ONS-2015-066

Subject Duke Energy Carolinas, LLC
Oconee Nuclear Station, Units 1, 2, and 3
Docket Numbers 50-269, 50-270, and 50-287
Renewed Operating License Nos. DPR-38, DPR-47, and DPR-55

Response to Request for Additional Information Regarding the License
Amendment Request (LAR) to Reduce Allowed Maximum Rated Thermal Power
When High Pressure Injection (HPI) Equipment is Inoperable
License Amendment Request No. 2013-03

Figure 1: Representative Temperature Distribution over the Fuel Pin Radius at Several Times during a 0.5-ft² CLPD SBLOCA

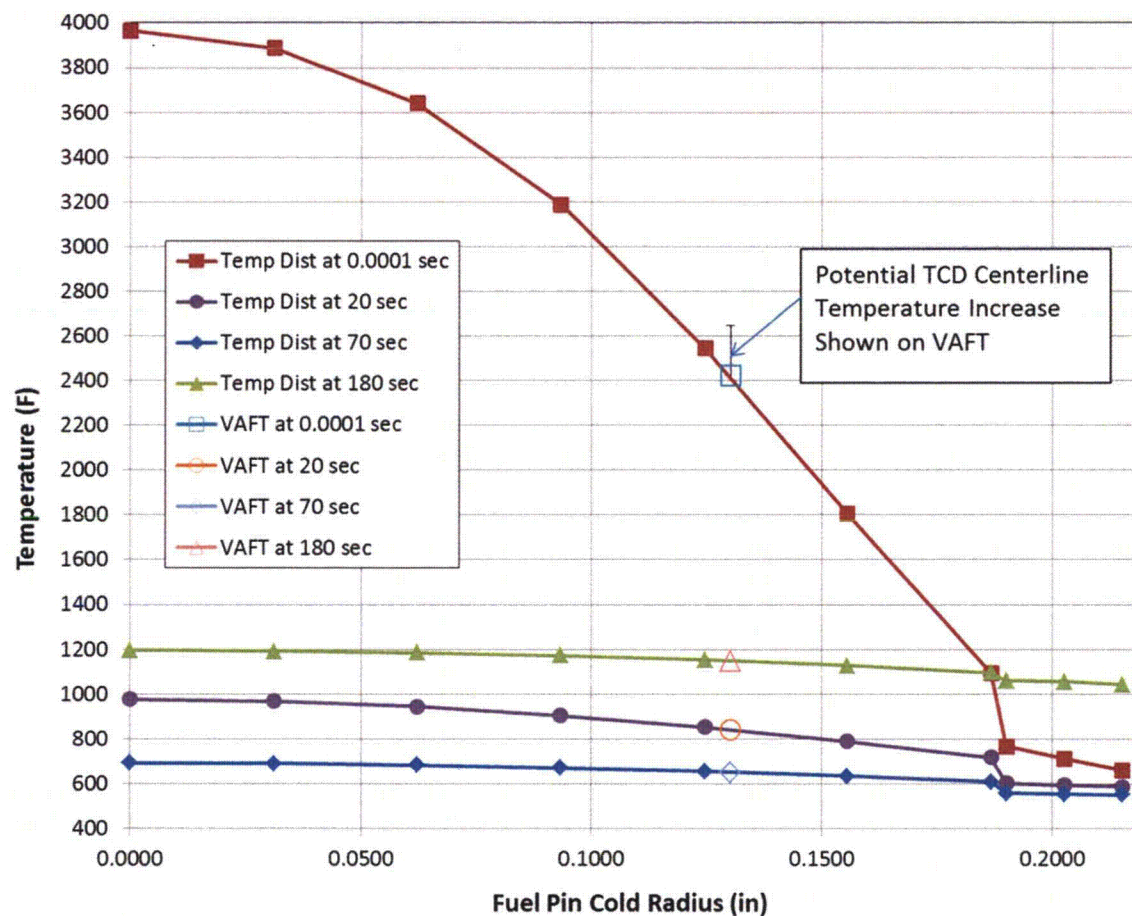
On November 26, 2014, AREVA, Inc. filed a report in accordance with Title 10 of the *Code of Federal Regulations* (10 CFR), Part 21 "Reporting of Defects and Noncompliance," addressing a defect in the LOCA analysis for B&W plants (ADAMS Accession No. ML14337A095). Explain the impact of the fuel Thermal Conductivity Degradation identified by AREVA in that report on the Oconee Nuclear Station's small-break loss-of-coolant accident (LOCA) analysis of record.

The temperature rise across the pellet at BOL was 2900 F just prior to break opening. If the temperature rise needs to increase by 280 F at MOL, then the effective thermal conductivity change needed across the pellet is effectively ~10% lower to account for the TCD. After reactor trip for an SBLOCA, the cladding remains in pre-CHF heat transfer regimes and this heat removal, combined with reactor trip to shut down the fission power, allows the fuel pellet temperatures to decrease rapidly. The fuel pellet VAFT drops to 840 F by 20 seconds into the transient as the temperature distribution equilibrates with the decay heat power production rate. The VAFT continues to drop as the decay heat decreases and it is down to 650 F at 70 seconds into the event. The fuel pin temperature distributions at 20 and 70 seconds are also shown in Figure 1.

The figure shows that the temperature change across the pellet is proportional to the power produced. The temperature distribution is established as a quasi-steady balance between the fuel power production and the thermal conduction that transmits it to the surface of the pellet,

across the gap to the cladding and finally into the coolant. At 180 seconds post trip (slightly after the PCT time for the 0.5-ft² CLPD break from either 102% or 52% full power), the decay heat contribution is approximately 4% full power (FP). Therefore, the initial 2900 F temperature rise across the pellet at 102% full power decreases by the power ratio to an estimated 114 F $\{2900 \text{ F} * (4\% * P_o) / (102\% * P_o)\}$, where P_o is the steady-state full power value. (Note: This simple estimate of fuel pellet temperature distribution is confirmed by the fuel pin temperatures taken from the 0.5-ft² CLPD break at 102% full power from the 180 second edit as shown in Figure 1.) If the 10 percent fuel temperature change due to TCD was applied to this temperature rise, it would be estimated that the centerline temperature could be roughly 12 F higher. Since the fuel thermal conductivity is lower, the VAFT could increase by roughly half of the centerline temperature, while keeping the same temperature change across the fuel pin gap that produced the previous PCT without TCD. Since the fuel temperature could increase, there would be less energy reaching the cladding and the PCT might be a few degrees lower. Another way to look at it is, if the VAFTs were the same, then half of the temperature change across the pellet could allow the PCT to be a few degrees lower. Regardless, the PCT with TCD stored energy and lower conductivity in the transient would be expected to be within +/- 6 F of the value calculated with BOL stored energy and the BOL thermal conductivity for the largest SBLOCA break size. It should be reiterated that the 0.5-ft² CLPD break does not produce the limiting PCT results and the LHR limit reduction used for LBLOCA TCD offset was not required or credited for SBLOCA.

For smaller break sizes, the time of PCT is later so the decay heat is lower. Thus, at the SBLOCA time of PCT, the ratio of the decay heat generation rate to full power is lower, so the impact of TCD on the PCT change would be proportionally lower as well. Given the small potential that TCD has to change the SBLOCA fuel pin temperature at the time of PCT, potentially either up or down, the PCT change for the limiting SBLOCA was estimated to be zero.

The effects of fuel pellet TCD on SBLOCA results has been considered for the spectrum of break sizes. The larger, non-limiting, SBLOCAs have the potential to be the most impacted; however, the potential change is very small and it could be slightly positive or negative based on quantitative values. Therefore, use of a value of zero is reasonable for all SBLOCAs that predict core uncovering and cladding heatup.
